Re: **#14ITB91556K-DB**
Construction Services for the Big Creek WRF Immediate Needs
Rehabilitation Project S-134

#14ITB91556K-DB; Construction Services for the Big Creek WRF Immediate Needs Rehabilitation Project S-134
Addendum No. 4
Page 2

This Addendum forms a part of the contract documents and **modifies** the original ITB documents as noted below:

DRAWING NUMBER:	D-09.03
SHEET:	113 OF 185
DATE:	3/17/2014
FILENAME:	3501D-30903.dwg
SCALE:

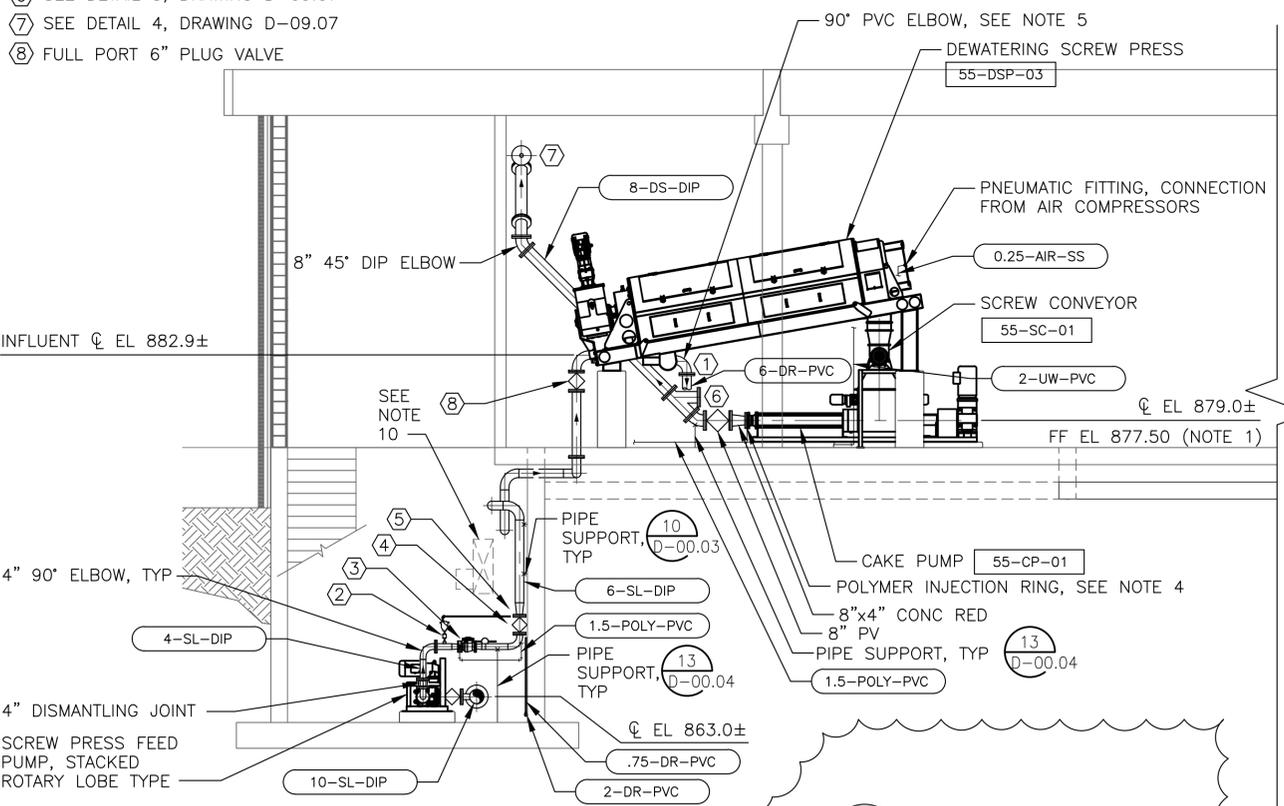
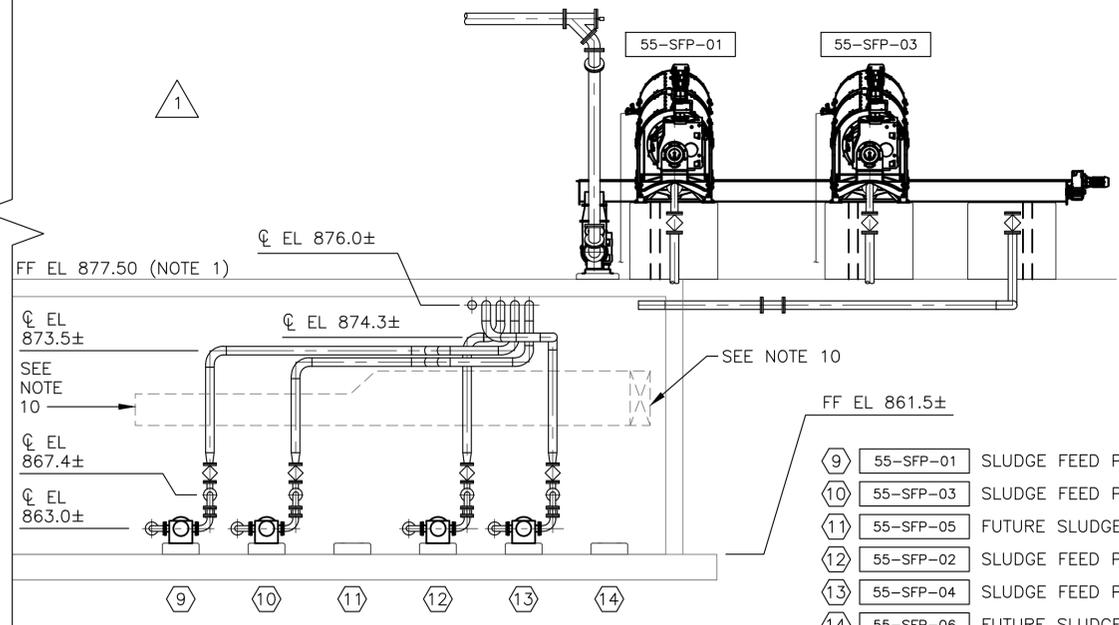
QUESTION:	10	2. Drawing D-09.03, note 9: Huber takes exception to the type of proposed injection ring as it is reducing the pipe cross section .
RESPONSE:	10	Answer: Secondary injection ring to be eliminated from the Scope of Work. Delete Notes 8 and 9 from the sheet.

QUESTION:	13	5. Drawing D-09.03 – There is no need for 5” reducer at screw press: screw press will be delivered with 6” flange connection .
RESPONSE:	13	See revised drawings attached to this addendum

QUESTION:	14	6. Drawing D-09.03 - INYO injection ring might be moved to suction side of pump – utilizing pump as additional mixing (OPTIONAL) .
RESPONSE:	14	Answer: Injection ring eliminated from the Contract.

RESPONSE:	9	Answer: See revised sheets D-09.02, D-09.03 and D-09.04. The Contractor will be responsible to coordinate with screw press manufacturer to ensure that the pipe configuration meets the screw press manufacturer requirements.

1. Delete the following drawings: D-09.02, D-09.03, D-09.04 and replace with the attached revised drawings: D-09.02, D-09.03, D-09.04.
2. Drawing D-04.02: Callout that states "Existing 36" DIP RAS Effluent" shall be revised to state "Existing 36" DIP Settled Effluent"
3. Drawing D-05.01: Add a note 9 that states the following: "Existing seal water system not shown for clarity. Contractor shall field verify seal water piping configuration and connect to existing for new RAS pumps. See also Specification 43 2149."
4. Drawing S-00.02, Section 10- Delete the phrase "by others".

DRAWING NUMBER:	D-09.04
SHEET:	114 OF 185
DATE:	3/17/2014
FILENAME:	3501D-10904.dwg
SCALE:

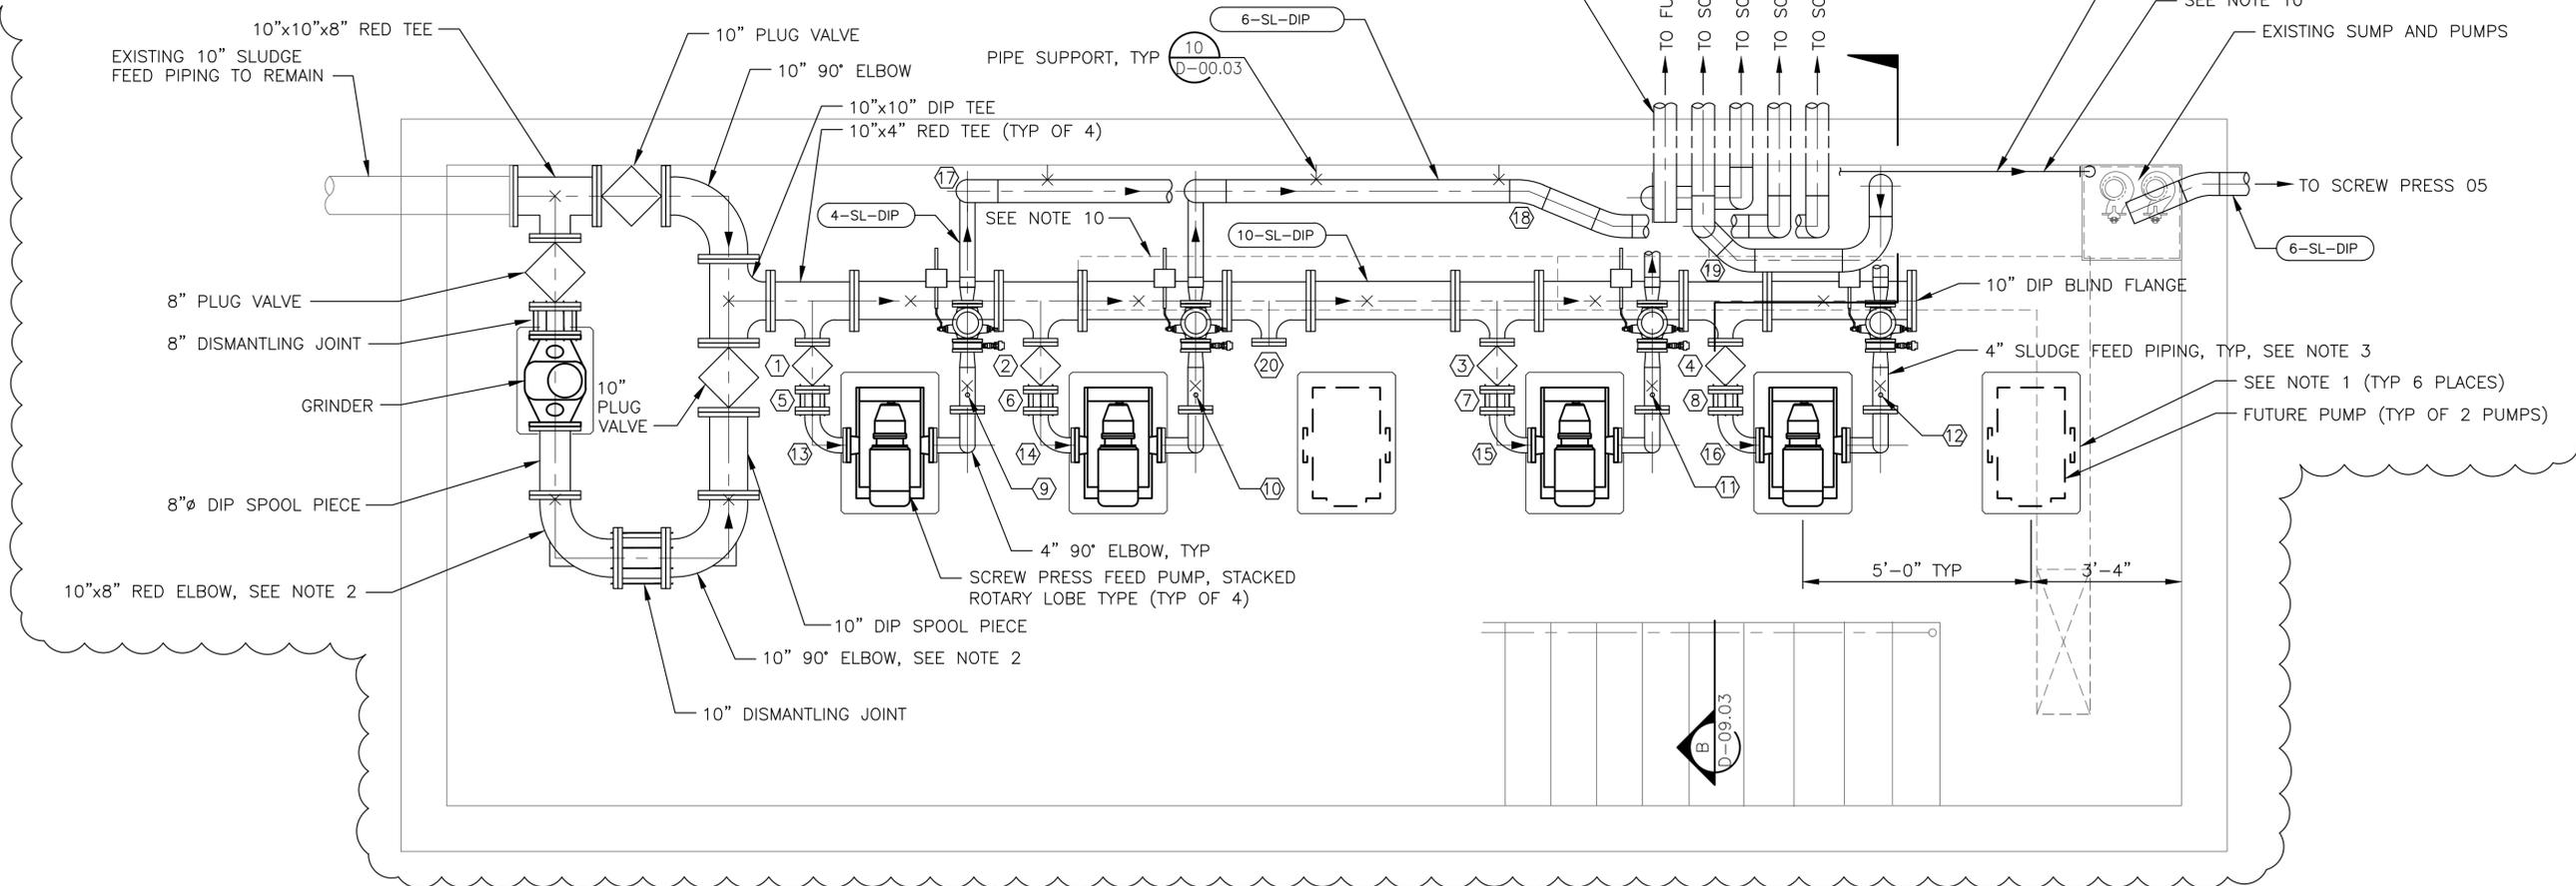
QUESTION:	12	4. Drawing - D-09.01- D-09.04 - Pipe design at pump outlet is not optimal: Huber suggests o 4" outlet of pump o Four inch line to plug valve o 4" line to Huber's injection and mixing device for polymer o Increase pipe diameter to 6" right after mixing valve o Eliminate check valve (item 6 in D-09.03); check valves are creating a lot of turbulence which affects the flocculation negatively o Pipe between polymer injection and screw press inlet shall not contain any items which reduce the cross section of the 6" pipe (see INYO injection ring, note above) o Full port plug valves are acceptable; eliminate all valves which are not providing full port opening for 6" pipe .

RESPONSE:	72	No modification of the existing grout are anticipated.
QUESTION:	73	16. Plan sheet D-09.04 & plan sheet DI-0901 call out & show the sludge feed discharge piping. Plan sheet D-09.04 shows what appear to be an injection ring & a valve. Plan sheet DI-09.01 shows this same line & calls out an injection ring & a blending valve. Plan sheet D-09.03 calls out an injection ring check valve assembly and a 6" plug valve. Specification section 46 7627, page 12, states polymer mixing valves shall be supplied by the screw press manufacturer. Are the two items shown on plan sheet D-09.04 an injection ring & a blending valve, and are these being supplied by the screw press manufacturer?

RESPONSE:	12	Answer: Pipe is actually shown as 4-inches from the pump outlet to the check valve downstream of the mixing valve. Equipment callout Nos. 4,5 and 6 on sheet D-09.04 to be changed to read 4-inches in diameter. Relocate mixing valve downstream of plug valve and eliminate current check valve. All plug valves to be full port type.

RESPONSE:	73	Answer: Yes, the Screw Press manufacturer must provide the polymer injection and blending valve.
QUESTION:	74	17. The cake pumps are specified to have 250# raised face discharge flanges, plan sheet D-09.01 calls out "cake pumping ductile iron piping is pressure class 250". Are the cake discharge piping & valves to be provided with 250# flanges?
